22 ESBWR PRA CHANGES

The ESBWR Design Certification PRA is being developed in parallel with plant design details. Already, significant safety benefits have been added to the ESBWR design based on PRA insights. To account for the effects of design changes on the PRA model, a PRA model update is performed so that the changes to PRA results can be quantified, evaluated, and applied to the design process. An update takes several months to perform. As such, it is a static representation of the plant that is based on the design information accumulated up to a specified point in time. The design phase is a dynamic process because additional detailed design information is still being developed in order to implement the functional design described in the Design Control Document. These design details enhance the understanding of the structures, systems, and components in the PRA model, and thus reduce uncertainties and eliminate assumptions. Continuing development of design details has a positive effect on the risk profile; however, the published PRA results do not account for up-to-date design information.

The PRA model update process accounts for this by including a "delta document," i.e

Figure 22.4.13-1. Simplified Diagram of HPNSS

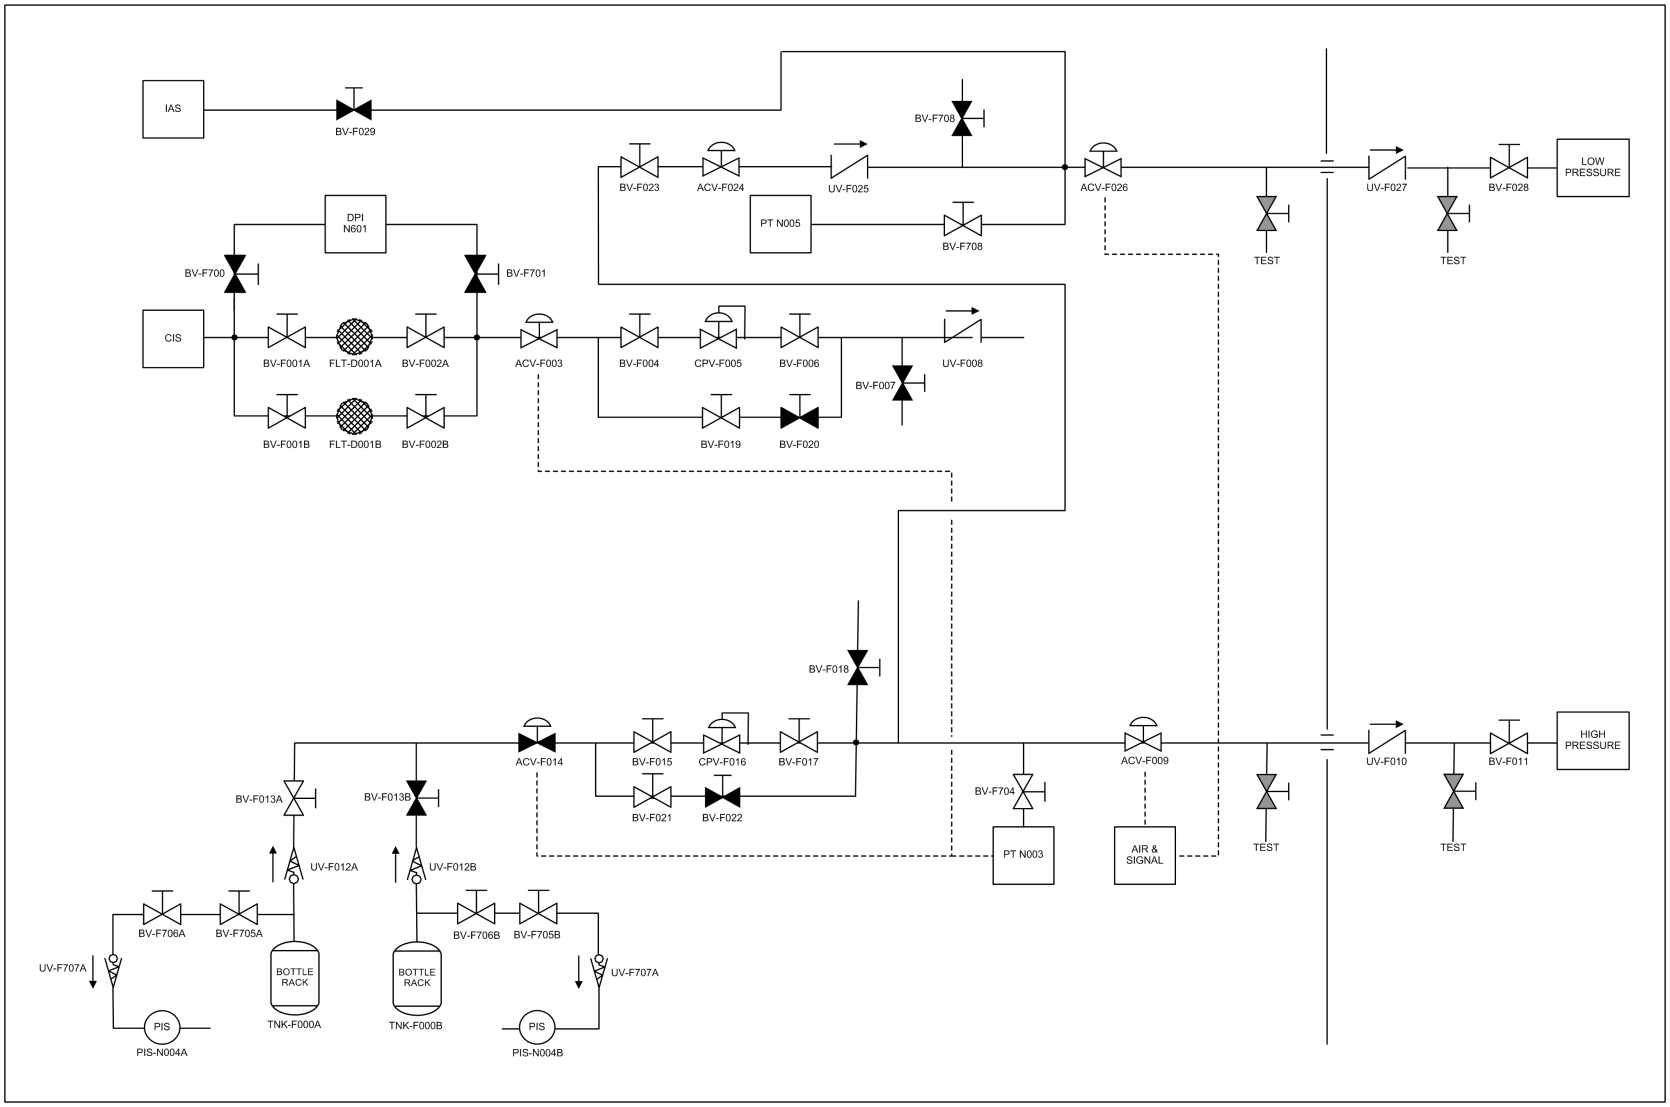
The normally closed maintenance valve on the low-pressure nitrogen supply line is renamed as BV-F708 as shown on Figure 22.4.13-1, Simplified Diagram of HPNSS.

Figure 22.4.14-1 Standby On Site Power Supply (Ancillary Diesel Generator Buses Only)
Sheet 1

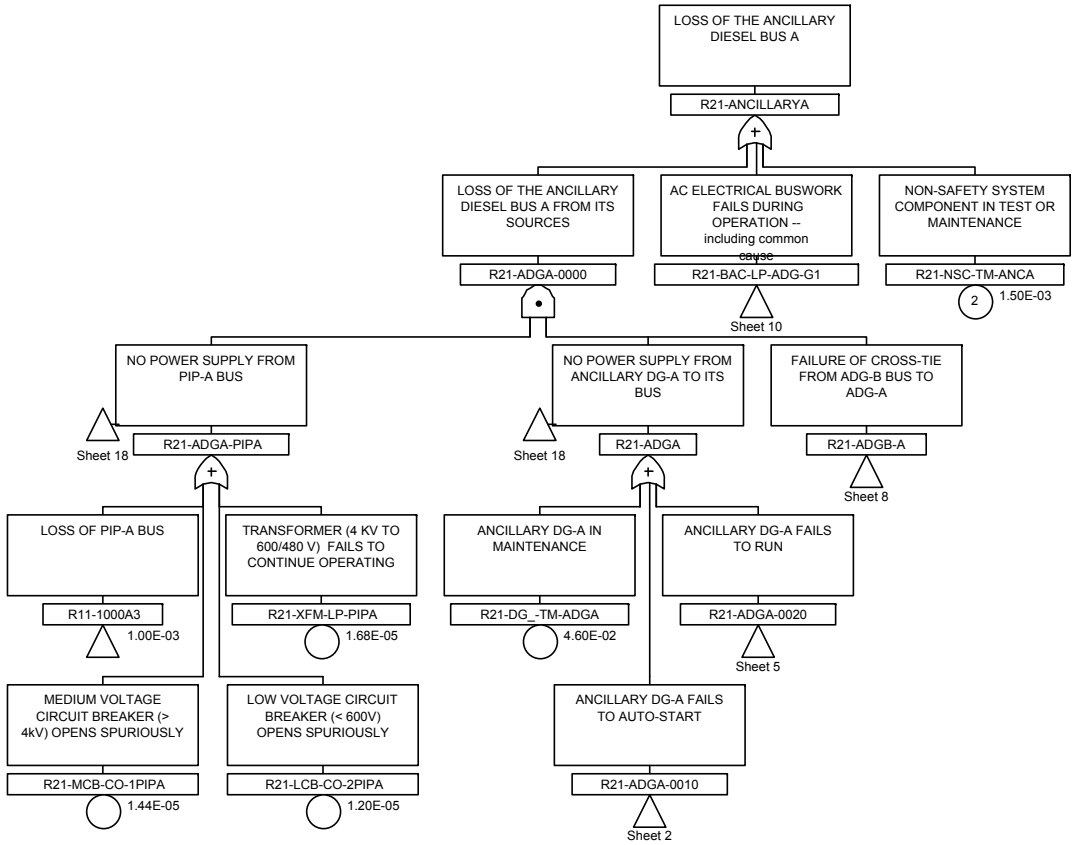
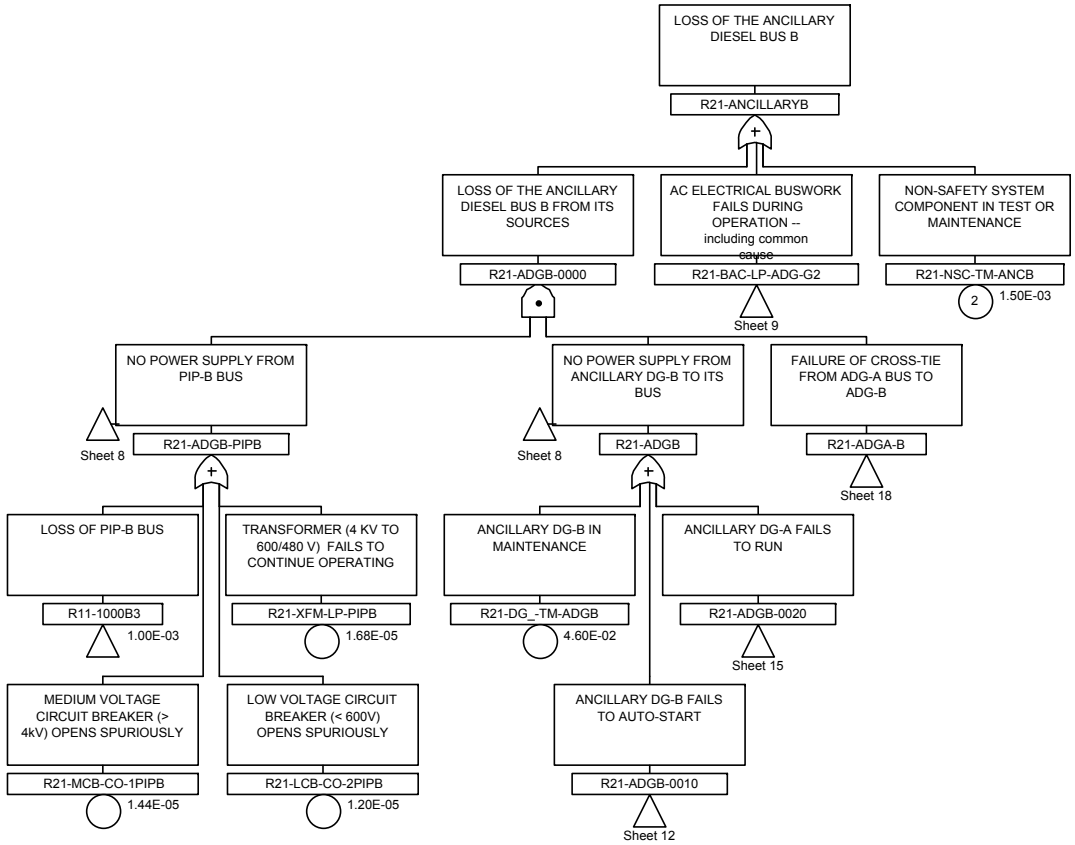
Two nonsafety-related ancillary diesel generators have been designed to provide additional independent sources of onsite AC power. DCD Tier 2 Section 8.3.1.1.9 and Figure 8.3-3 describe the ancillary diesel generators. Although the ancillary diesel generators are totally independent of the standby diesel generators, they are included in the R21 PRA system model for convenience.

Figure 22.4.14-1 shows the fault tree developed for the new system tops R21-ANCILLARYA (Sheet 1) and R21-ANCILLARYB (Sheet 11).

Figure 22.4.15-1 Uninterruptible AC Power (System Tops R13-11-CB and R13-NSR-CBA Only)

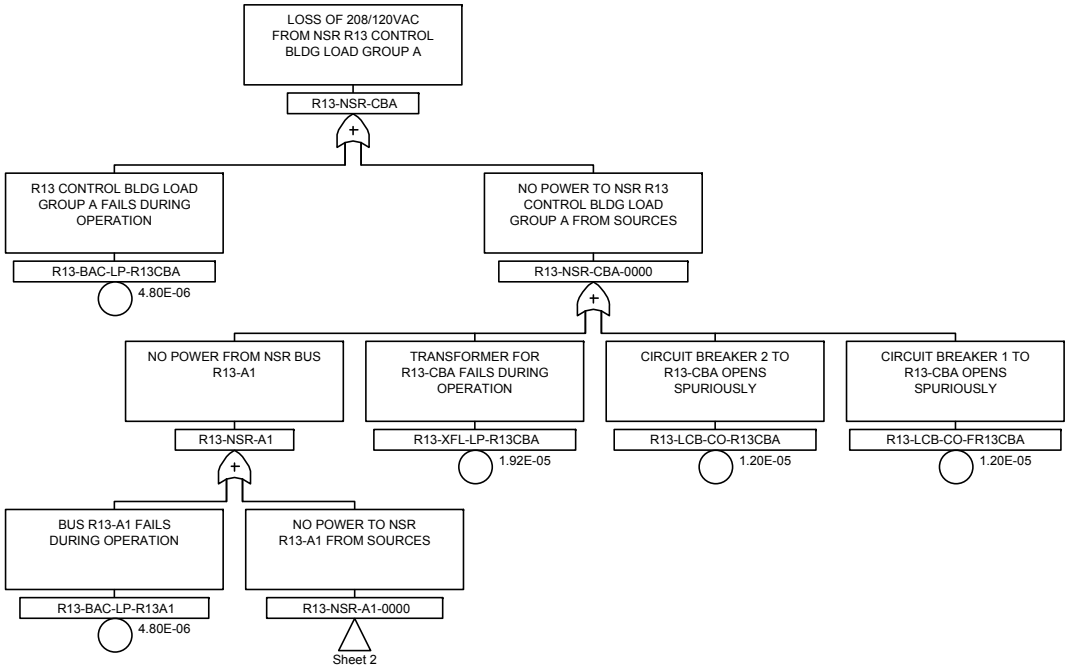
Figure 22.4.15-1 shows the updated fault tree developed for the following two long-term UPS system tops:

- R13-11-CB (Figure 22.4.15-1 Sheet 8): Loss of SR 120VAC UPS from Bus R13-11 for Control BLDG
- R13-NSR-CBA (Figure 22.4.15-1 Sheet 1): Loss of 208/120VAC from NSR R13 Control BLDG Load Group A

Figure 22.4.16-1
Revised LPCI Simplified Diagram

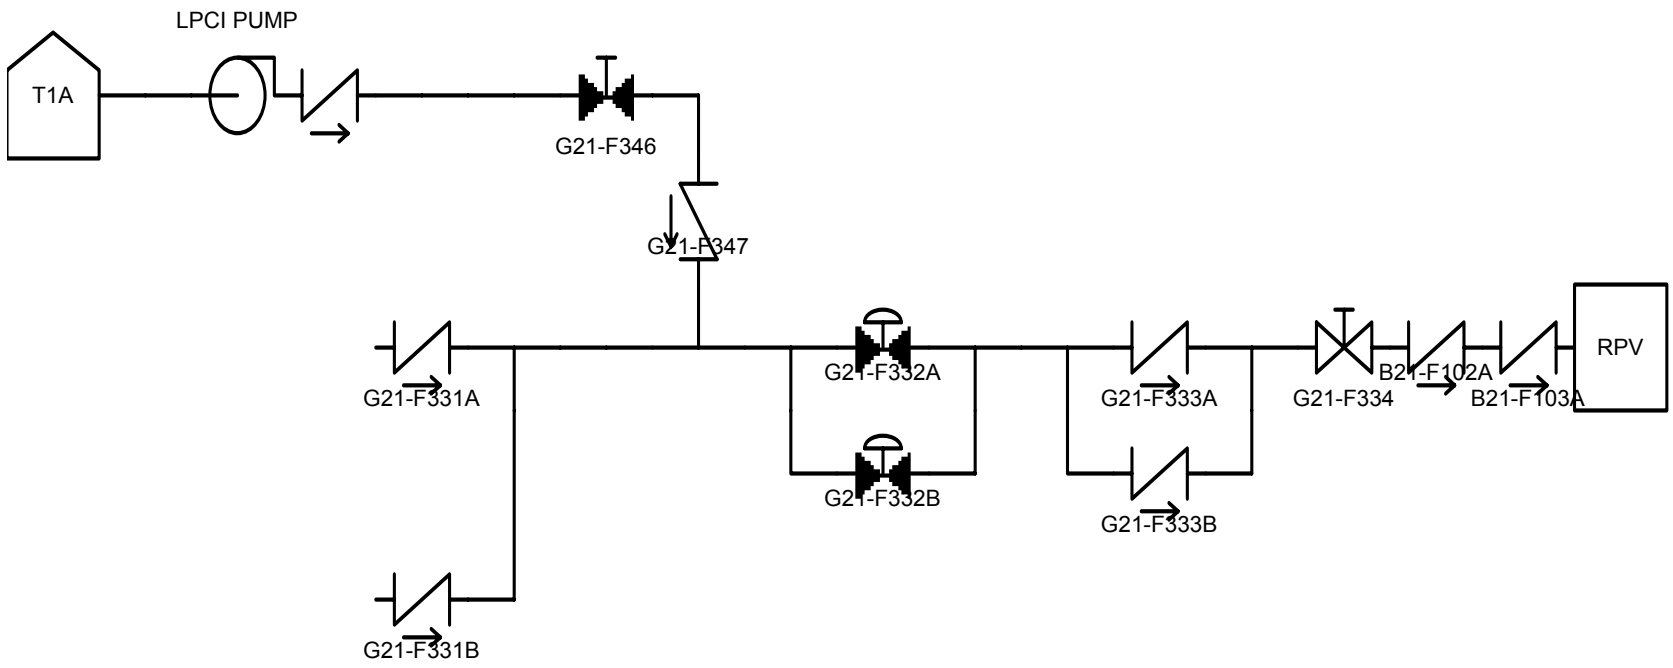
to function. The same operator actions associated with the Revision 2 model have also been unchanged for the Revision 3 model. There are no significant changes to the actions/scenarios to justify updating the logic. Figure 22.4.16-1 shows a simplified diagram of the new system. Table 22.4.16-1 shows the cutsets from the VM-TOPINJ gate for both the Revision 2 and Revision 3 versions of the FPS model.

Figure 12.4.18-1 Top Gate DS-TOPVB

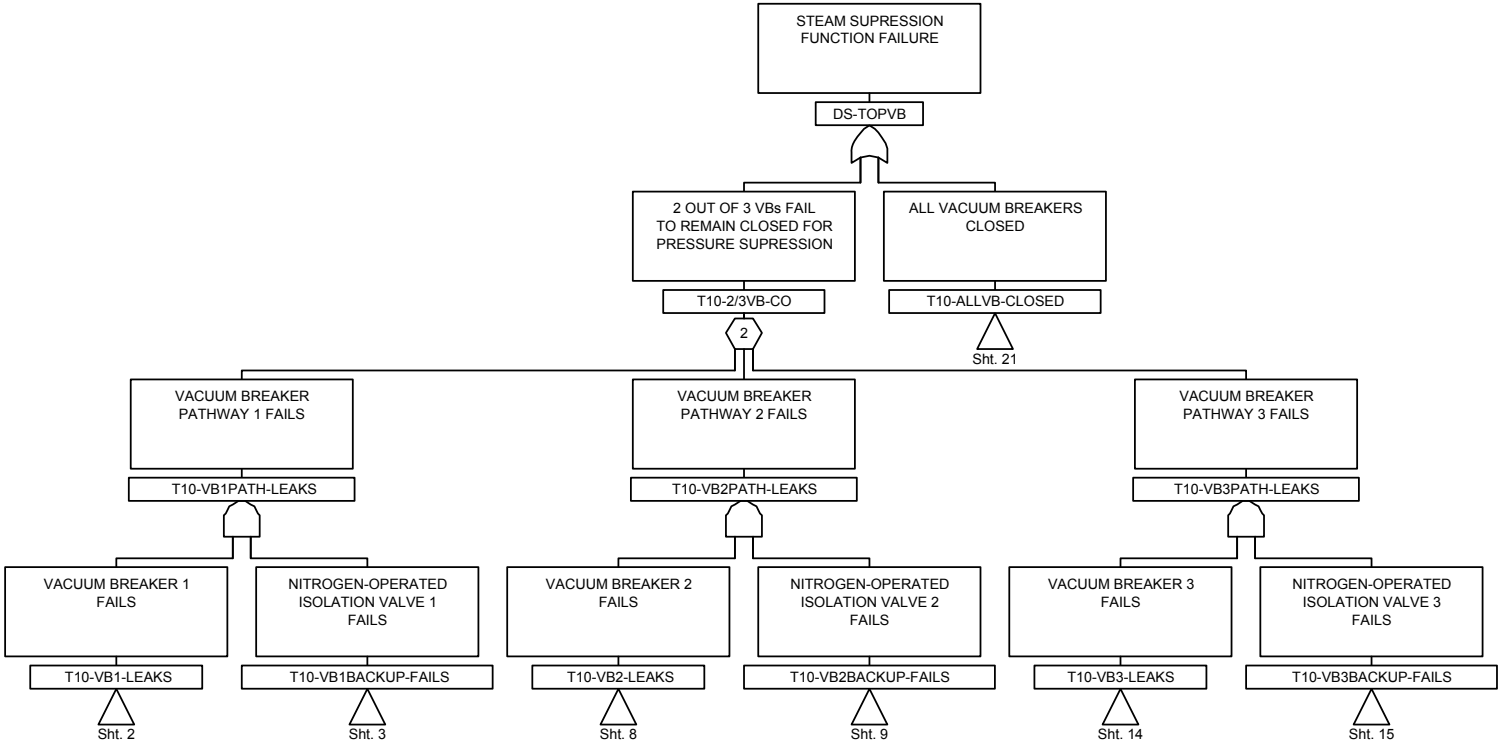
The fault tree for the VBIV model change is shown in Figure 22.4.18-1, which is a complete representation of top gate DS-TOPVB (Steam Suppression Fails). The tree is shown without the common cause failure tool applied; this makes the tree easier to read and much shorter. The common cause modeling associated with the new VBIV is summarized in Table 22.4.18.2.2-1.

Figure 22.4.18-2 Top Gate DL-TOPVB Top Logic

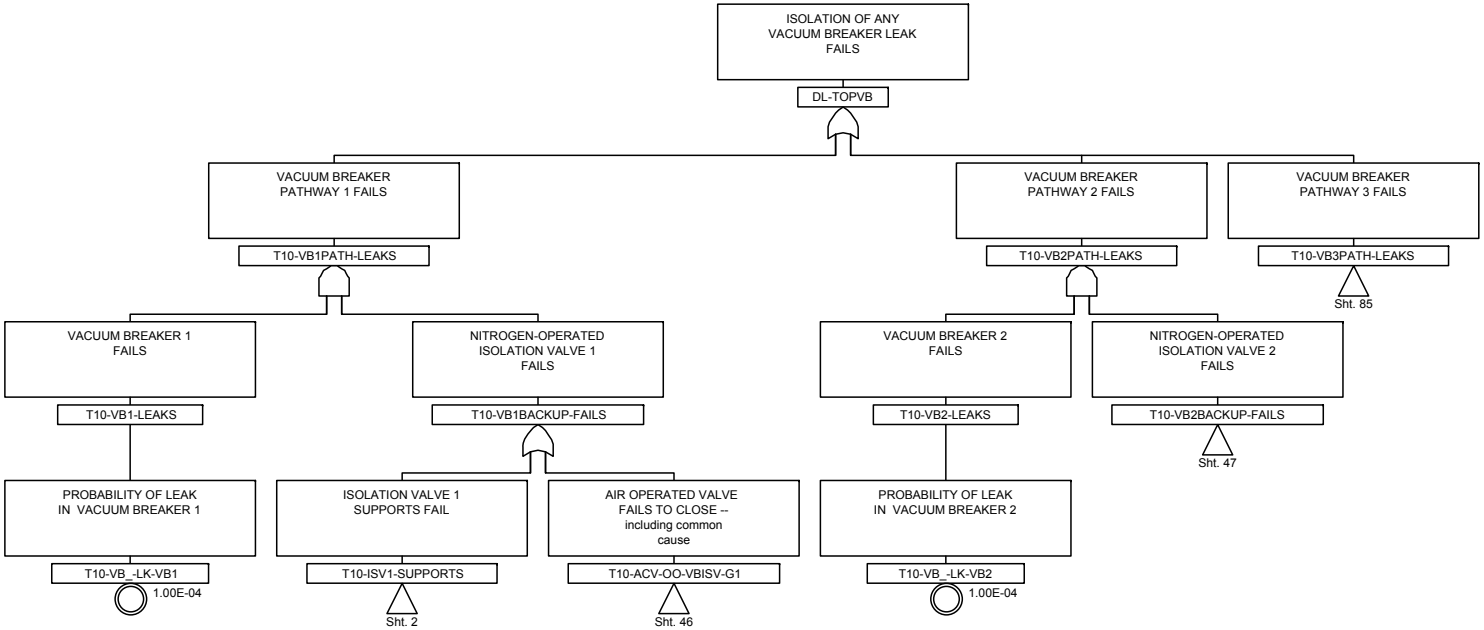
The upper level logic for top gate DL-TOPVB (Failure to Isolate All VB Leakage) is shown in Figure 22.4.18-2; gates used below what is shown are identical to those shown in Figure 22.4.18-1.
